STAFF REPORT

AGENDA ITEM: Shoreland Variance Request to exceed the allowed impervious surface within the shoreland district as well as exceed the allowed maximum driveway width – 7962 Hill Trail.

RESOLUTION NO 2018-126

BURNS SITE PLAN

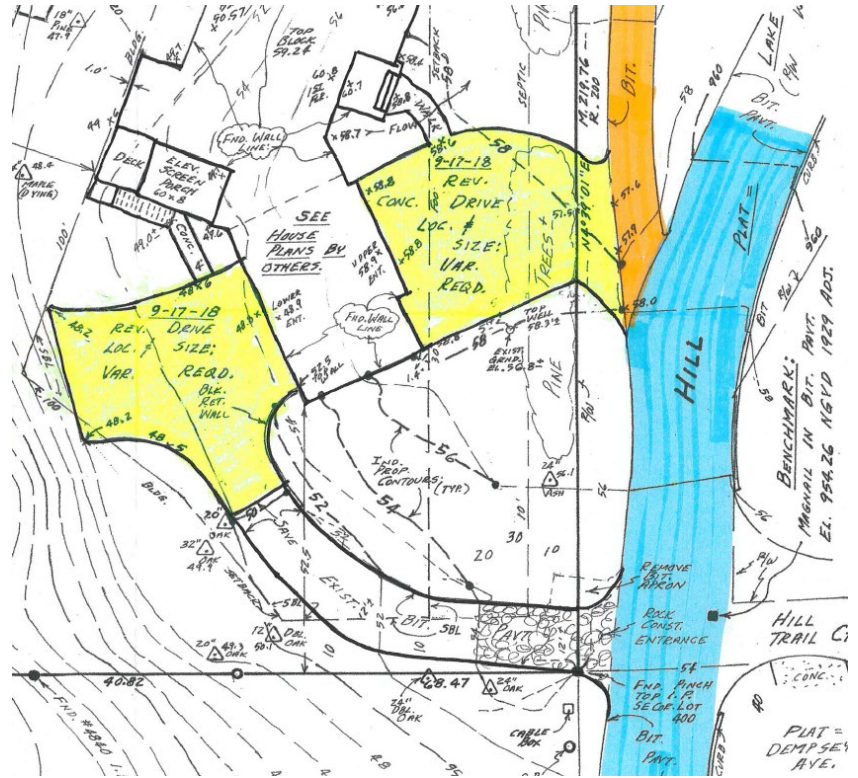
- The previously approved plans for the site allowed the applicant a main driveway width of 18ft. as well as the 12 ft. for the second smaller driveway. This also exceeds the allowed limit of 26ft. by 4 ft. The current proposal would exceed the limit by 16 ft.

- Though the driveway comes out onto a private drive the ROW technically extends the width of the front lot line (see graphics for visual). Being that this is the case the maximum width will still apply. Because of the topography of the driveway to the private drive the applicant has stated that they have had difficulty transitioning from the garage and driveway and then onto the private road (see section f. of the applicant’s narrative). Also, due to the layout of the lot the applicant states it made most sense to create a two level garage to utilize the smaller driveway that previously existed.

As shown the driveway does technically fall within the City ROW which is why the variance is needed for an increased width, but instead of connecting to a public street the driveway comes out onto a private drive. After discussing the request with Public works it was stated that the City does not maintain the private

drive. Because of this staff does not feel the impact of replacing the space between the ROW to the property line would be as impactful when discussing the larger driveway. Unless the street is reconfigured there would not appear to be an increased cost to the city when the street is repaired.

Primary Driveway
for 7962 Hill Trail

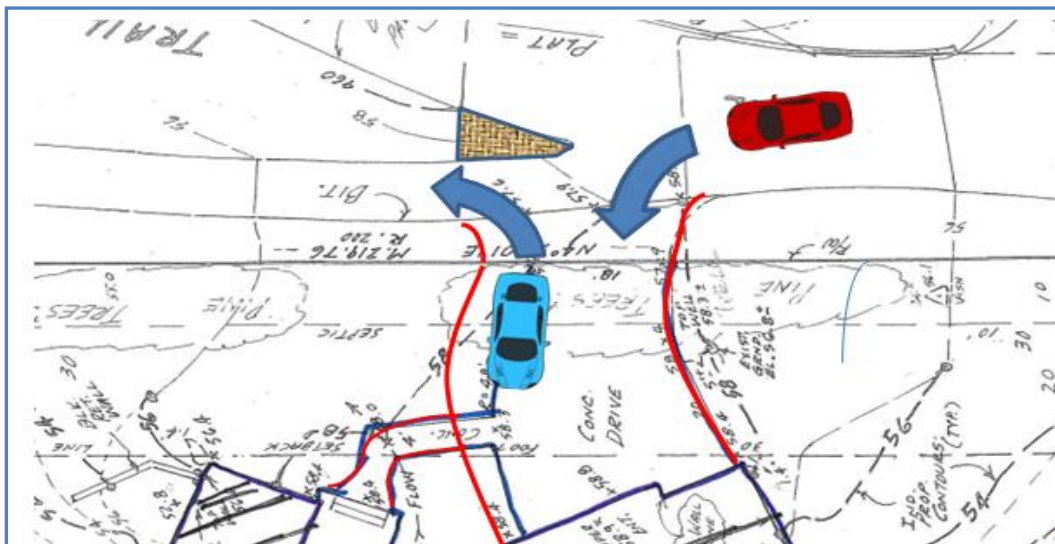
Because of the location of the "split" in the roadway between Hill Trail N and the private driveway that services our property as well as properties 7972 / 7978 / 7982 Hill Trail N, access to our driveway is challenging. In addition to the split, because Hill Trail is sloped upwards following the elevation of the hill (to the North) and the private driveway is sloped downward - there is an elevation change at that point that is too steep to drive over with standard vehicles.

The following two pictures illustrate this issue. The first image shows the elevation change from the middle of the proposed driveway. The second image shows how Hill Trail N slopes upward while the private driveway to the neighbors slopes downward.

Because of this situation, following is a depiction of how we currently enter the driveway traveling Northbound on Hill Trail (red car) and how we back out onto the private driveway to leave the property (blue car). This approach works currently because the existing red rock (temporary) driveway is wider than the driveway width drawn on the original survey. Note: The red driveway outline is similar to the newly proposed driveway and the blue line is the outline from the original survey (partially covered by the blue car). Because Hill Trail can be busy and it is difficult to see up the hill when backing up, it is not safe to back directly onto Hill Trail (plus it would be quite a navigational feat).

The two main issues with the upper driveway that was drawn on the original survey is that it's width narrows quickly to only 18' at the lot line and because of the impervious surface limits, it is too narrow to safely navigate backing onto the private driveway. As a test, we marked off the footprint of the driveway from the original survey and tried to back a car out of the right hand garage stall and onto the private driveway. It was very difficult to crank the wheel for the driveway bend near the house without nearly hitting the right hand side of the garage door frame and we usually ended up driving off the edge of the "marked" driveway where it was reduced to only 18' at the lot line. And this was my wife and I doing these tests - who utilize the driveway every day. It will be even more of an unsafe struggle for friends / visitors who would be unfamiliar with the difficult bends in the driveway.

Also, the width of the driveway where it meets the private driveway needs to be wide enough to allow entry from Hill Trail (red card in the previous picture) making sure to clear the "split" in the road and also provide a safe way to back onto the private driveway (blue car in the previous picture). After many trial attempts we found that 30' will provide enough width to meet both of these requirements. Interestingly, the originally approved survey had a width of 30' at the street.
